REVIEW COMMENTS

FILE #87-93

TITLE HEADING: Site Plan Review - Cactus Coatings

LOCATION: 1015 South 15th Street

SITE PLAN

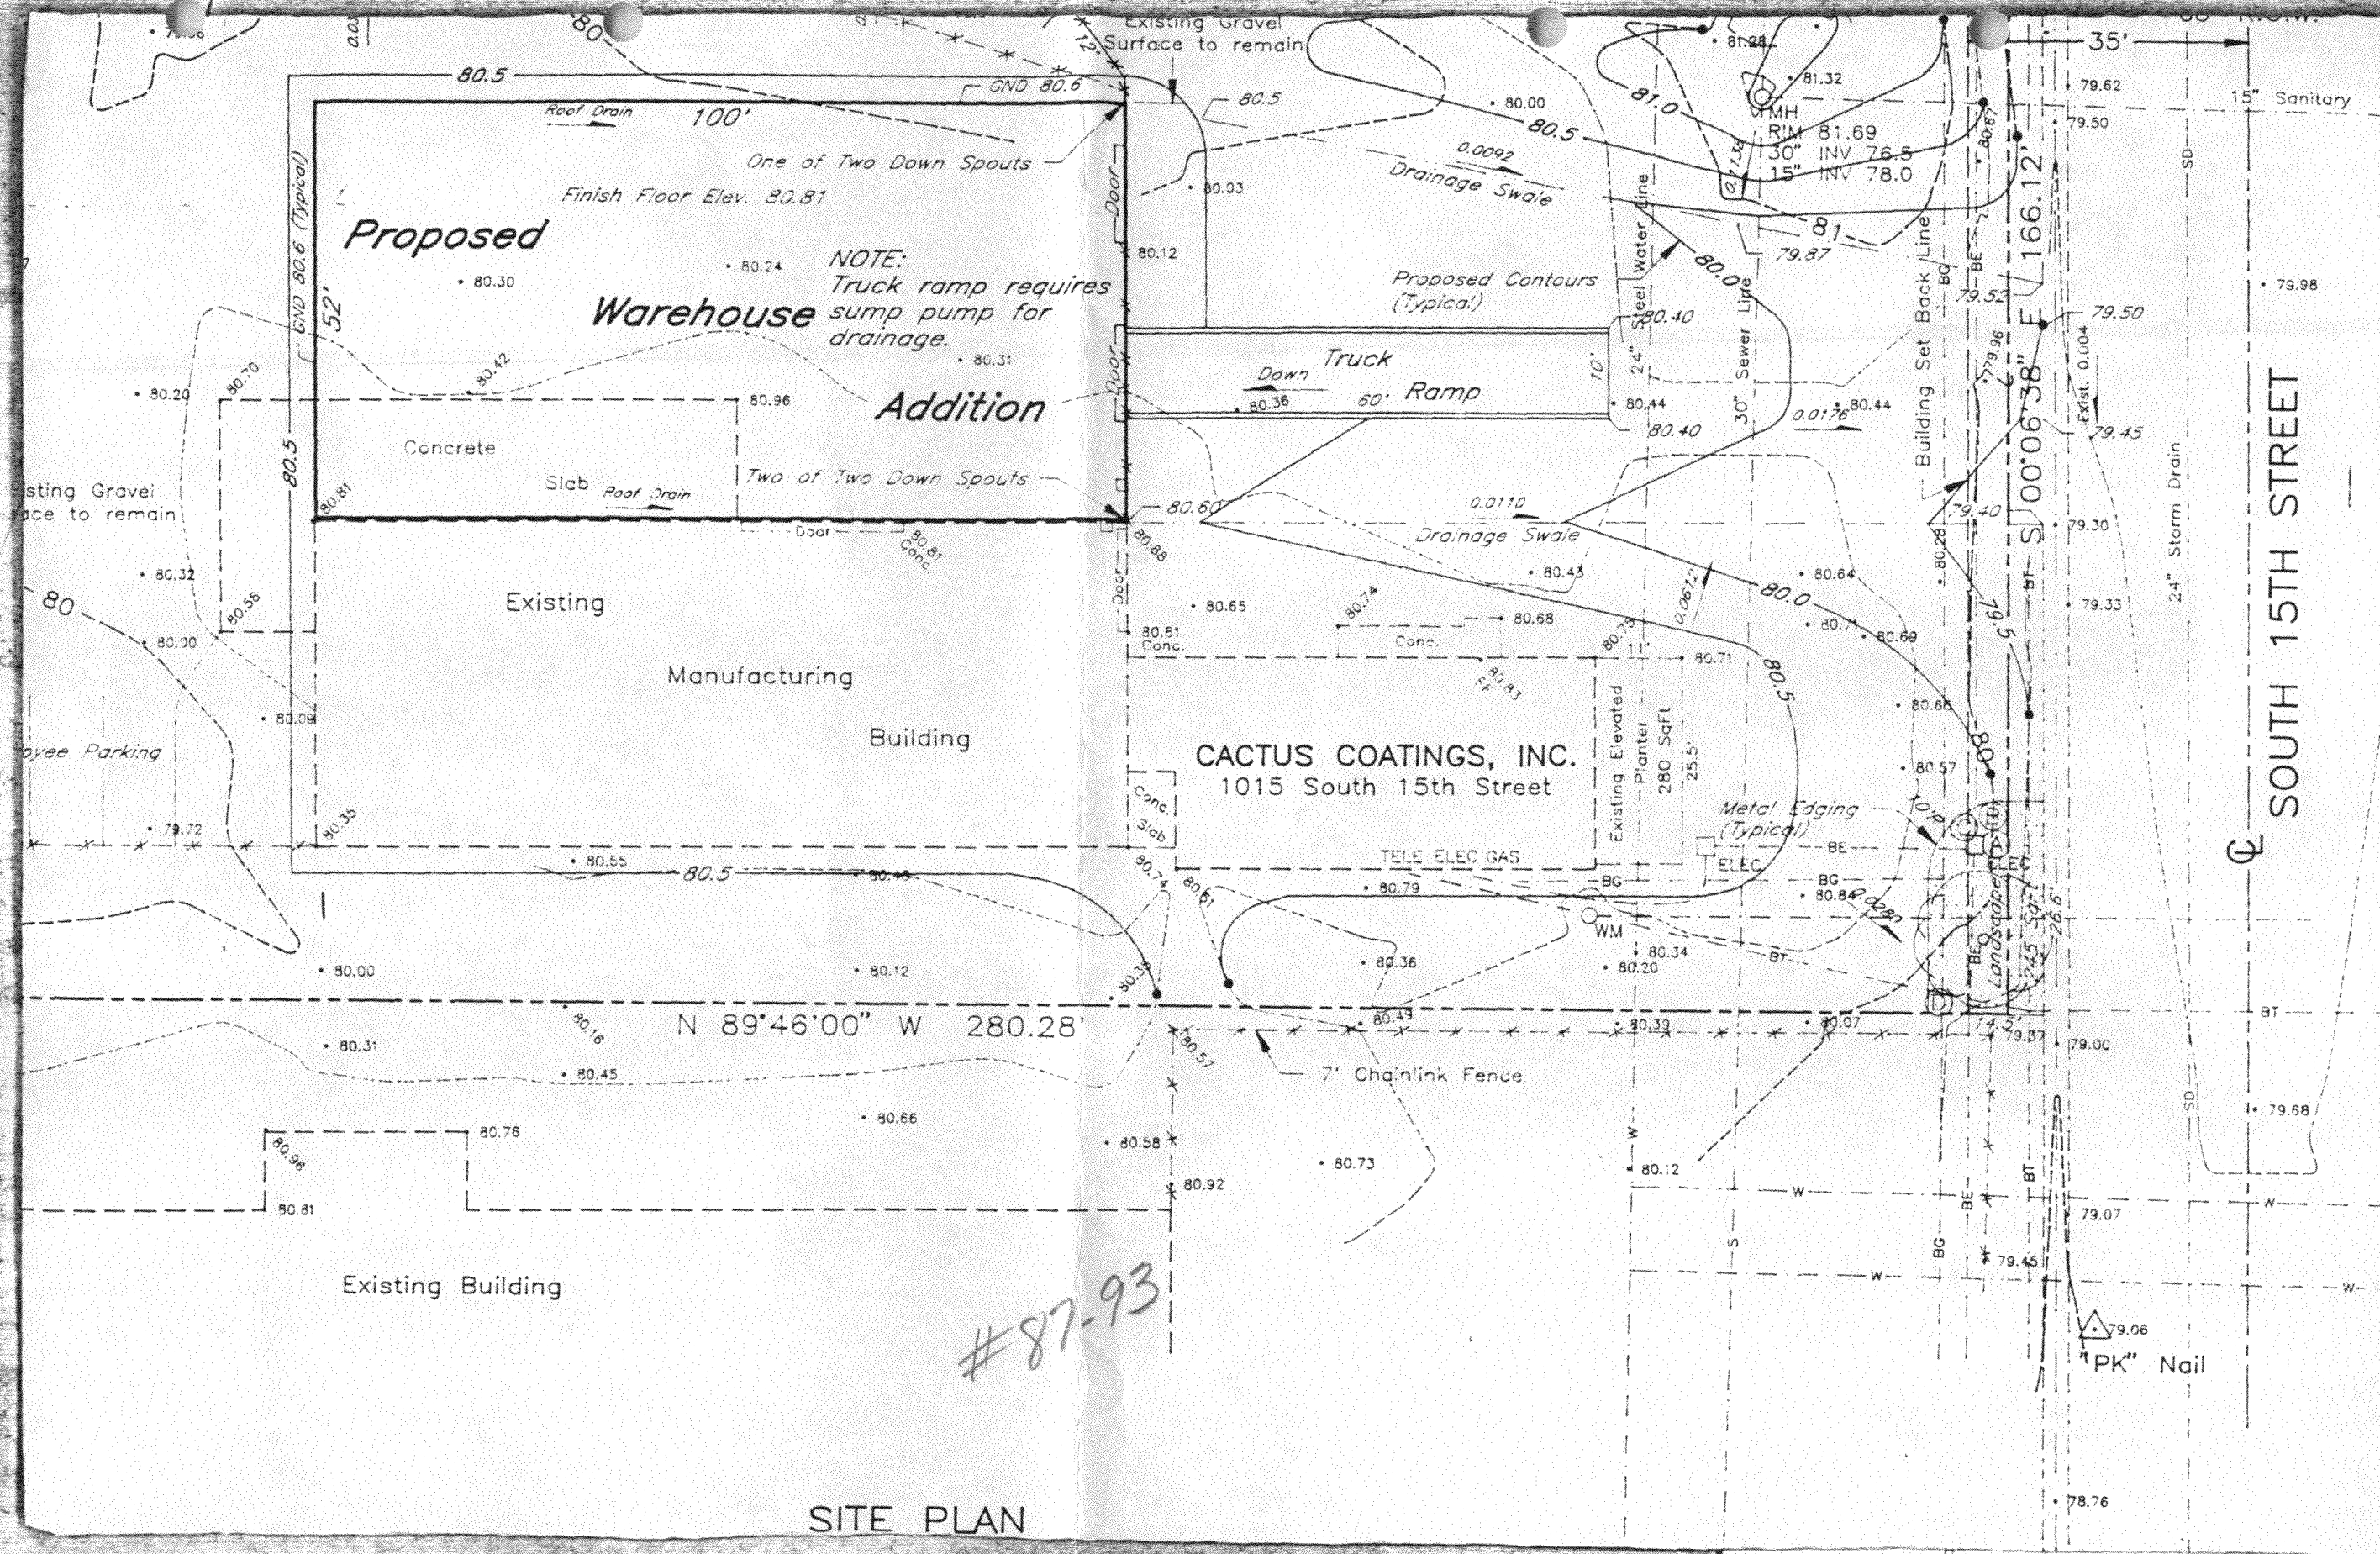
Landscaping requirement is $166' \times 5' \times .75 = 622.5$ square feet with 2 trees and 40% of the landscaped area in shrubs. The proposed 904 s.f. as shown on the site plan meets that requirement. Please locate all shrubs within the property boundaries instead of in the right-of-way. Bark or other organic ground cover is preferred over rock. Additional shrubs or trees would be nice but not required.
